ORDINANCE 2013-02

AN ORDINANCE OF THE CITY OF TOLAR, TEXAS, ADOPTING THE 2012 INTERNATIONAL RESIDENTIAL CODE THAT IS WRITTEN BY THE INTERNATIONAL CODE COUNCIL, AS THE STANDARD BY WHICH ALL CONSTRUCTION OR INSTALLATION PERFORMED WITHIN THE CITY LIMITS IS JUDGED; AND ADOPTING THE NCTCOG (NORTH CENTRAL TEXAS COUNCIL OF GOVERNMENTS) RECOMMENDED AMENDMENTS TO THE 2012 INTERNATIONAL RESIDENTIAL CODE AND REPEALING ALL ORDINANCES AND PARTS OF THE ORDINANCES IN CONFLICT THEREWITH.

**Recommended Amendments to the
2012 International Residential Code**
North Central Texas Council of Governments region

****Figure R602.6.1; delete the figure and insert the following figure:**

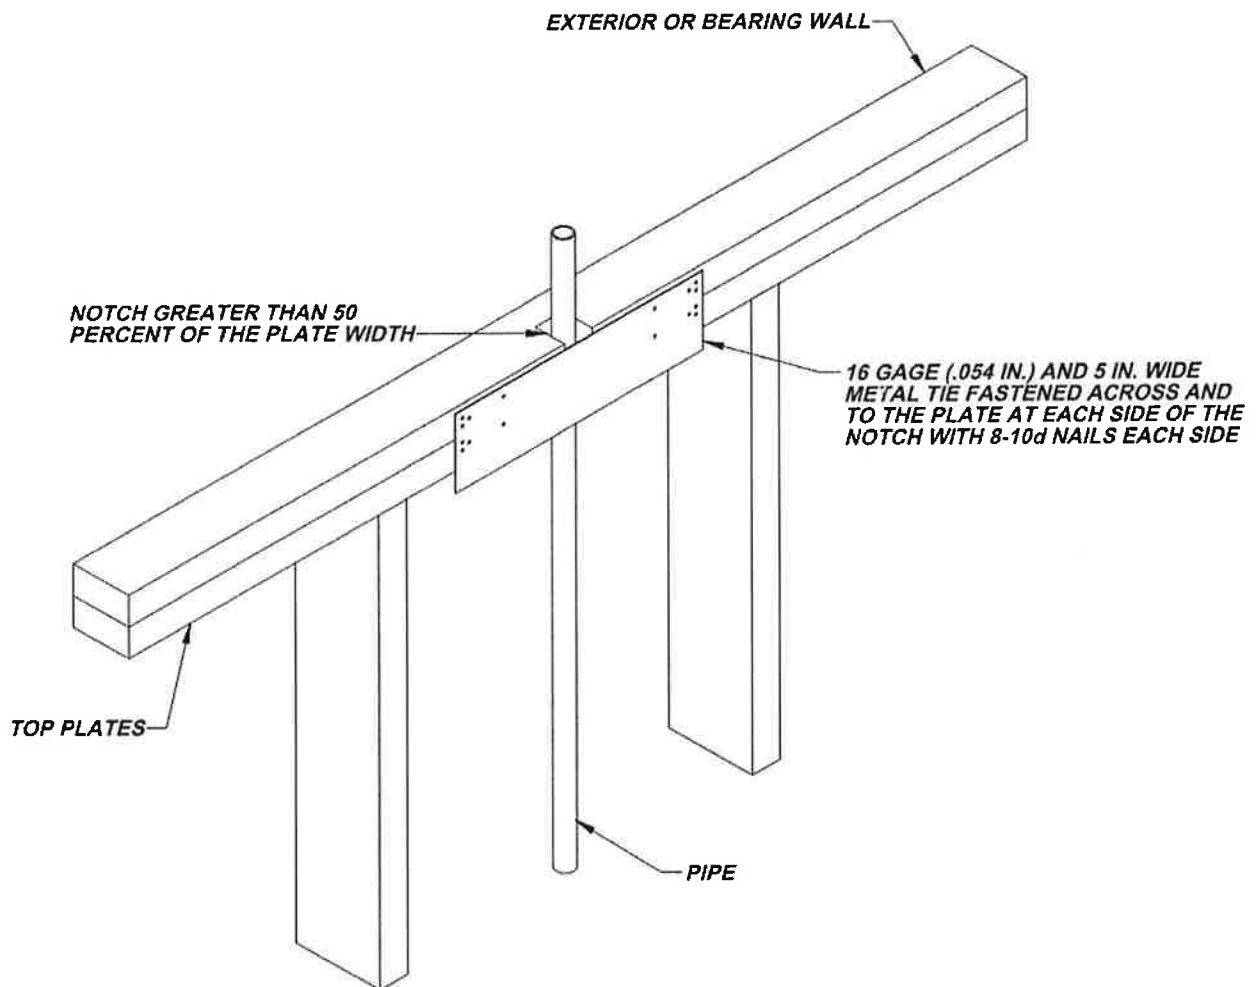
R602.6.1 Drilling and notching of top plate. When piping or ductwork is placed in or partly in an exterior wall or interior load-bearing wall, necessitating cutting, drilling or notching of the top plate by more

than 50 percent of its width, a galvanized metal tie not less than 0.054 inch thick (1.37 mm) (16 Ga) and 4 ½ inches (38) mm 5 inches (127 mm) wide shall be fastened across and to the plate at each side of the opening with not less than eight 10d (0.148 inch diameter) having a minimum length of 1 ½ inches (38 mm) at each side or equivalent. Fasteners will be offset to prevent splitting of the top plate material. The metal tie must extend a minimum of 6 inches past the opening. See figure R602.6.1. {remainder unchanged}

(Reason: reflects regional practice and to comply with P2603.2.1. Also provides additional assurance of maintaining the integrity of the framing by spreading the nailing pattern.)
